DAIRYLAND POWER
COOPERATIVE

SUBJECT: Dairyland Power Cooperative
La Crosse Boiling Water Reactor (LACBWR)
Request for Amendment to 10 CFR 50, Possession-Only License in Support of Dry Cask Storage Project

Dairyland Power Cooperative (DPC)
La Crosse Boiling Water Reactor (LACBWR)

Request for Amendment to 10 CFR 50, Possession-Only License in Support of Dry Cask Storage (DCS) Project

LACBWR
CANAL GATE AND HOUSING

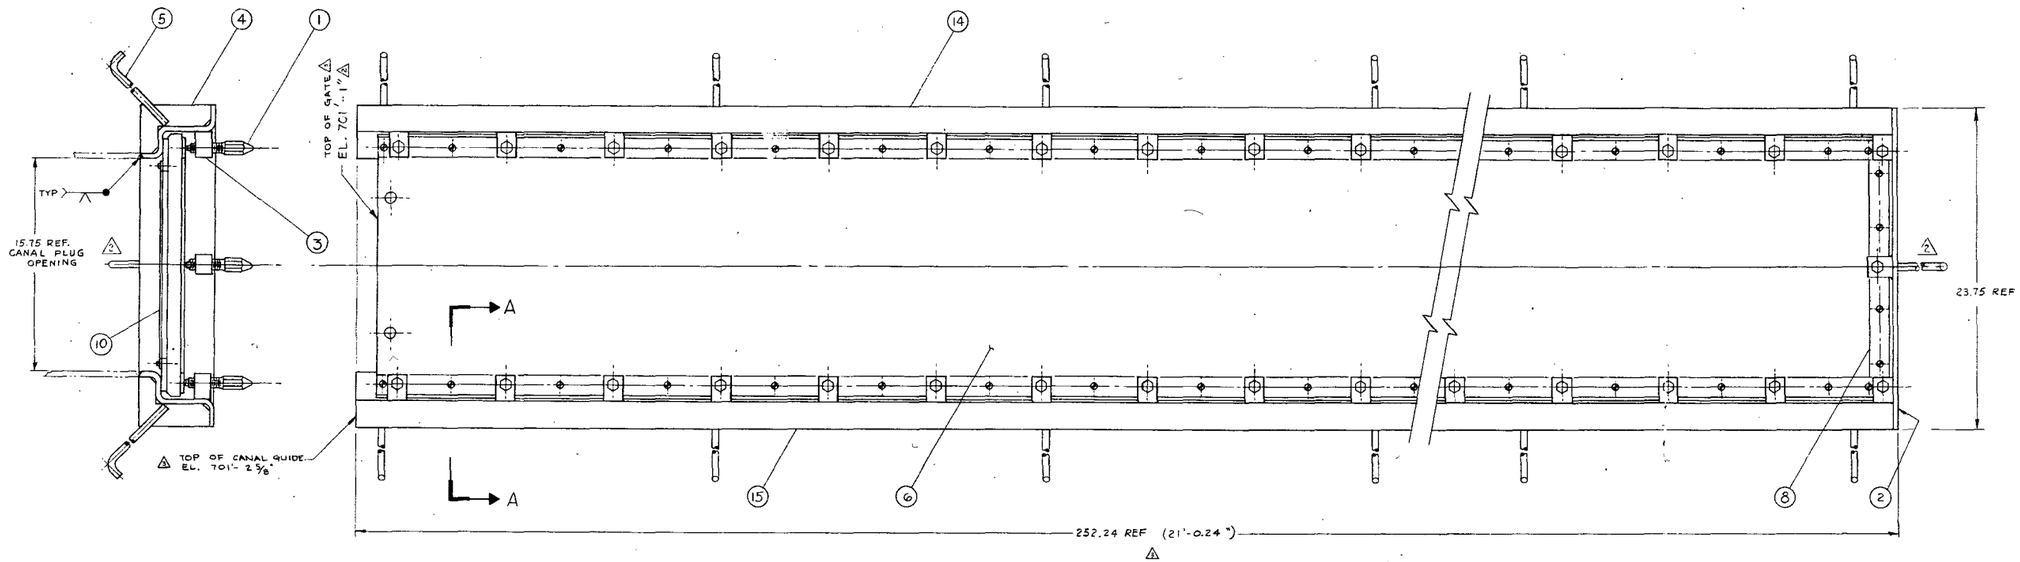
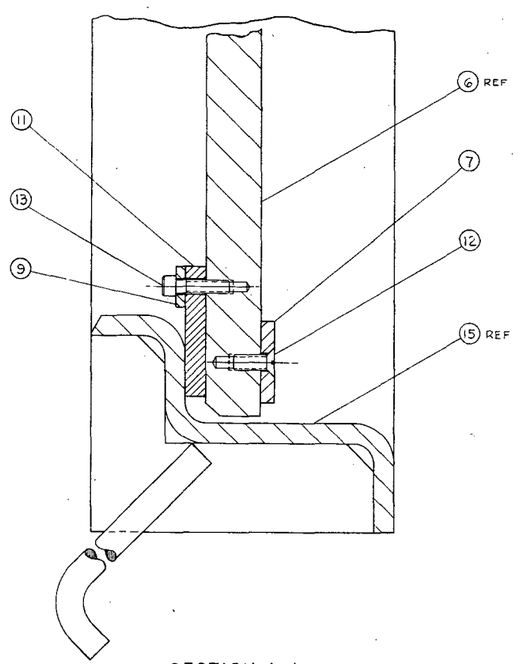
The transfer canal gate is held in place by 65 threaded jacking bolts that compress the gate onto the sealing surface (References 4 and 5). Each bolting and unbolting operation requires use of a long-handled manual ratchet tool and takes significant time, estimated to be 6 hours, and a five person work crew. Such transfer canal gate operations would cause these personnel to incur unnecessary occupational dose if LCO 4.1.2.a. were to remain unchanged. Moreover, the fuel transfer canal gate has not been removed in 22 years, presenting a significant operational risk of not being able to obtain a watertight seal each time the gate is installed. Repairs and potential seal replacements would incur additional radiation exposure to personnel if the gate was not to seal properly after one or more reinstallations.
